Re: CPUC Concurrence with PG&E Minor Project Refinement 5 for the Manning 500/230 kV Substation Project

Attachment 1: Manning 500/230 kV Substation Project PG&E MPR-5 Form

Manning 500/230 Kilovolt Substation Project CPUC Minor Project Refinement (MPR) Form

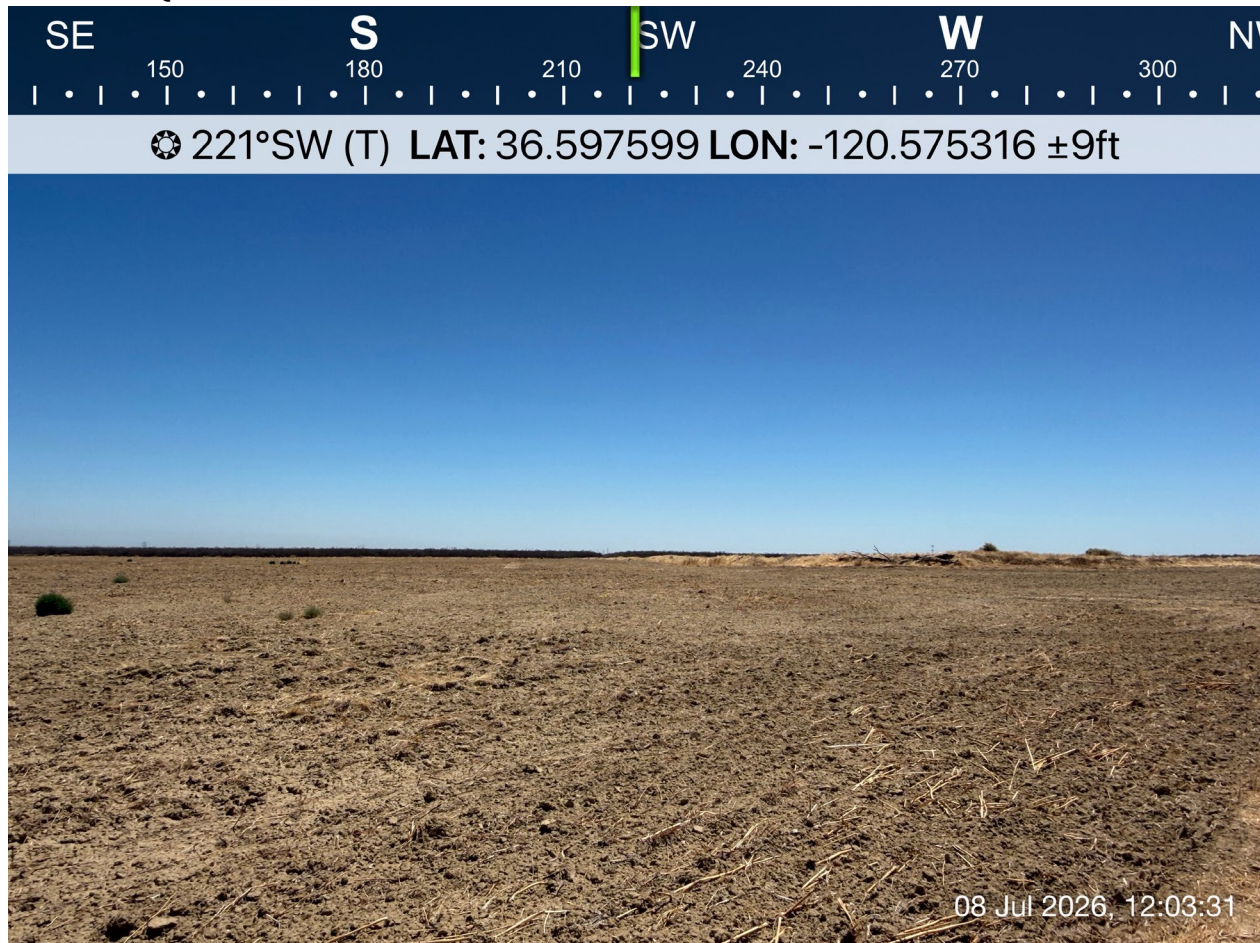
Item 1: 230 kV Structure Location Shifts

The IFC designs for the “230 kV Interconnections” and “230 kV Reconductoring”, as described in Section 2.6.2 of the final IS/MND, included minor shifts in 13 structure locations, necessitating shifts in the mapped Structure Permanent Disturbance areas. In some cases, these shifts also necessitated modifying the location of the Structure Work Areas and Pull Sites.

Structure/Pull Site Number	Revision	Landcover	Change in Temporary Impacts (acres)	Change in Permanent Impacts (acres)
230 kV Reconductoring				
5/31 (5/29)	2-pole TSP structure changed to single TSP structure	Agriculture	0	-0.007211 acres
6/38 (7/36)	TSP shifting ~65' to the west	Agriculture	0	0
7/44 (8/42)	TSP shifting ~60' to the west	Agriculture	0	0

10/56 (10/54)	TSP shifting ~55' to the east	Agriculture	0	0
230 kV Interconnections				
5/28	Single TSP structure changed to 2-pole TSP structure	Agriculture	0	+0.007211 acres
7/38	TSPs shifted ~40' to the west	Bromus rubens	0	0
7/39	TSPs shifted ~130' east	Agriculture*	0	0
1/10	TSPs shifted ~80' to the east	Agriculture*	0	0
Pull Site 7/39 NW	Shifted ~130' to the east	Agriculture*	0	0
Pull Site 7/39 NE	Shifted ~30' to the north-west	Agriculture*	0	0
Pull Site 1/10 NW	Shifted ~110' to the east	Agriculture*	0	0
Pull Site 1/10 NE	Shifted ~120' to the north-east	Agriculture*	0	0
Structure Work Area for 7/39	Shifted ~230' to the north-east and reshaped to accommodate new location	Agriculture*	+0.010861	0
Structure Work Area for 1/10	Shifted ~70' to the north-east and reshaped to accommodate new location	Agriculture*	+0.076074	0
0/2	Shifted ~20' to the east	Agriculture	0	0
Structure Work Area for 0/2	Shifted ~35' to the east	Agriculture	0	0

8/47	Shifted ~150' to the north-west	Agriculture	0	0
Structure Work Area for 8/47	Shifted ~150' to the north-west	Agriculture	0	0
8/48	Shifted ~130' to the north-east	Disturbed	0	0
Structure Work Area for 8/48	Shifted ~130' to the north-east	Disturbed and Agriculture	0	0
0/1A	Shifted ~145' to the north and split from one TSP to a two-pole H-frame structure	Disturbed	0	+0.007211 acres
Structure Work Area for 0/1A	Shifted ~145' to the north	Disturbed and Agriculture	0	0

0/1B	Shifted ~200' to the north and split from one TSP to a two-pole H-frame structure	Disturbed	0	+0.007211 acres
Structure Work Area for 0/1B	Shifted ~200' to the north	Disturbed and Agriculture	0	0
Pull Site 8/48 SE	Shifted from NW side of pole to SE side of pole.	Disturbed and Agriculture	0	0
Pull Site 8/48 E	Shifted ~150' to the north	Disturbed and Agriculture	0	0
Pull Site 0/1A SE	Shifted ~160' to the north	Disturbed and Agriculture	0	0
Pull Site 0/1A E	Shifted ~180' to the north	Disturbed and Agriculture	0	0
Pull Site 0/1B SE	Shifted ~220' to the north	Disturbed and Agriculture	0	0
Pull Site 0/1B E	Added, it was an oversight had this pull site was missing in prior map iterations. Part of the pull site overlaps other project temporary work areas.	Disturbed and Agriculture	+1.167418	0
TOTAL			+1.254 acres	+0.014 acres

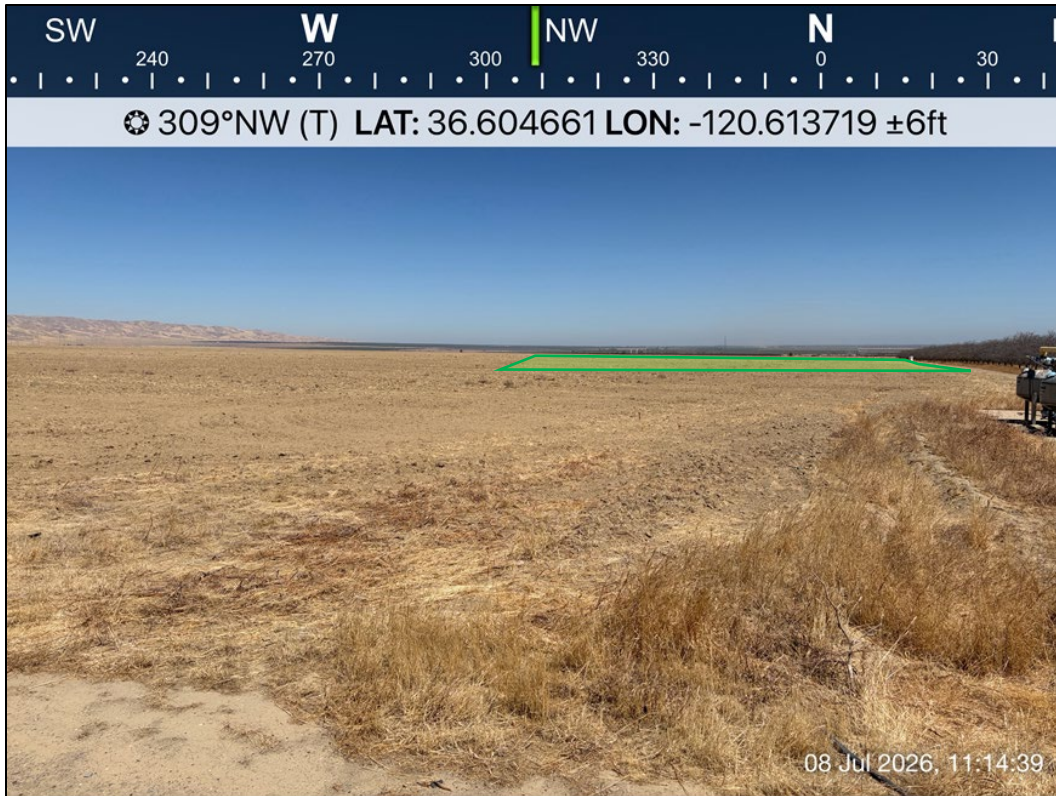
Item 3: 500 kV Interconnections Work Area Shifts

PG&E reevaluated the construction plan for the 500 kV Interconnection scope of work, given our recent findings of giant kangaroo rat (GKR) within this area. This resulted in modifying the location of the Structure Work Areas, Pull Sites, Temporary Access Roads, and a Staging/Landing Zone. Many of these mapping revisions were simply resizing the mapping to ensure the impact areas were precisely mapped according to the dimensions identified in Table 2-7 of the final IS/MND.

Work Area	Revision	Landcover	Change in Temporary Impacts (acres)
Staging/LZ 38/160	Relocated 0.45-mile to the north east to be outside of GKR habitat. Please see Photo 2 below.	Agriculture	0
PS 38/160A	Shifted 60' south to be centered on alignment.	<i>Avena spp.</i> – <i>Bromus spp.</i>	0
PS 38/160B	Shifted 50' north to be centered on alignment.	<i>Amsinckia</i> – <i>Phacella spp.</i>	0
PS 38/160E-2 N	Shifted 50' north-east to be centered on alignment and resized.	Disturbed	-0.09 (reduced mapped impact area to align with dimensions of Table 2-7)
PS 38/160E-1 N	Added pull site.	Disturbed	3.21 total 1.51 separate disturbance (accounting for overlap with adjacent pull site and structure work area)
PS 38/160E-2 E	Shifted 50' north-east to be centered on alignment and resized.	Disturbed	0.47 (updated mapped impact area to align with dimensions of Table 2-7)
PS 38/160E-1 E	Added pull site.	Disturbed	3.21 total 1.86 separate disturbance (accounting for overlap with adjacent pull site and structure work area)

PS 38/161A-1	Shifted 70' north to be centered on alignment and “squared up”.	Disturbed	-1.6 (reduced mapped impact area to align with dimensions of Table 2-7)
PS 38/161A-2	Added pull site.	Disturbed	3.21 total 1.98 separate disturbance (accounting for overlap with adjacent pull site)
PS 38/161C-1 NE	Shifted 230' southwest to be centered on alignment and resized.	<i>Amsinckia</i> – <i>Phacella spp.</i>	-1.67

Photo 1: Image from July 2026 of disced agricultural field to the east of Interstate 5, which was originally mapped as Amsinckia and Atriplex lentiformis in the final IS/MND.

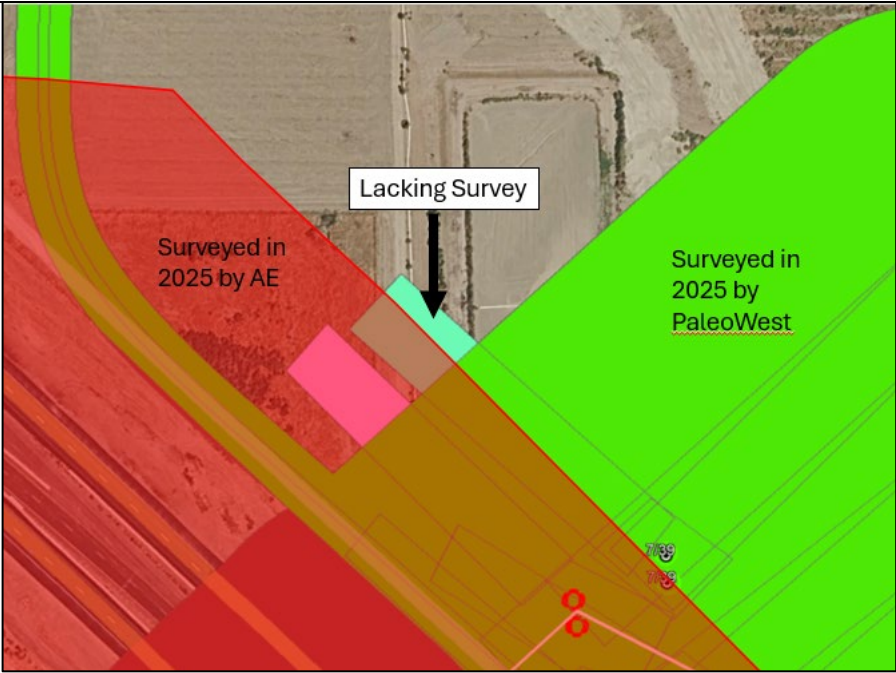
*This area is mapped as *Amsinckia* and *Atriplex lentiformis* in the final IS/MND. However, the landowner disced this field in May 2026, converting this landcover to Agriculture. Please see Photo 1 below.
